UNITED STATES NUCLEAR REGULATORY COMMISSION WASHINGTON, D. C. 20555

Docket No. 50-155

RE: BIG ROCK POINT

5% damping

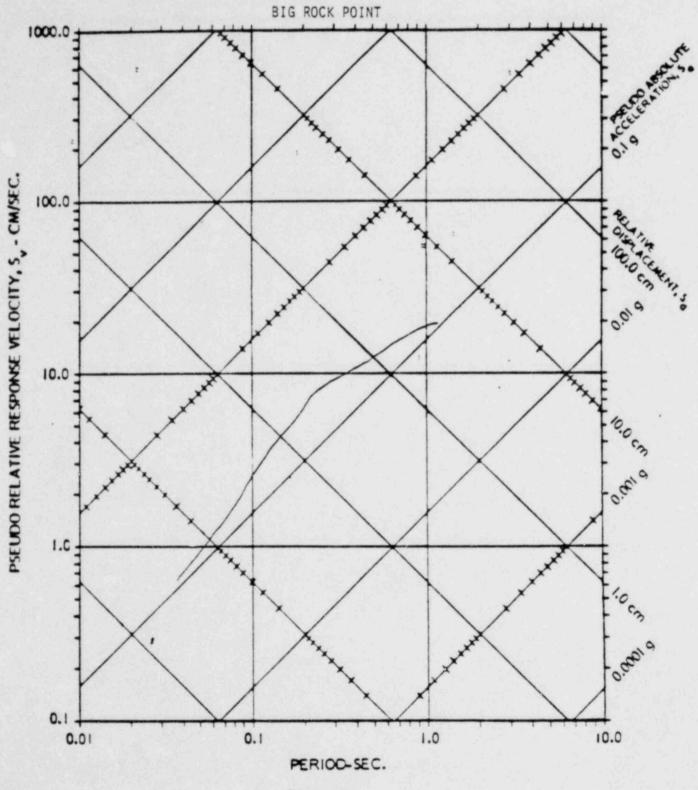
Although we have delayed until the end of 1980 a final decision relative to seismic input to maximize the potential benefits to be derived from use of site specific ground response spectra, we expect you to proceed with your seismic evaluation program. Based upon input that we have received from the Lawrence Livermore Laboratory/TERA Corporation Site Specific Spectra Project, the Systematic Evaluation Program licensees, NRC consultants and other sources, we have concluded that the ground response spectra shown in the Attachment 1 is an appropriate level at which to initiate your evaluations. Between now and the end of 1980 we plan to complete additional work that will allow us to finalize our decision. It does not appear likely that the ground response spectra shown

in Attachment 1 will be modified to a large degree. Therefore, we strongly recommend that you use this ground response spectrum in your evaluations. The bases for our decision are documented in Attachment 2.
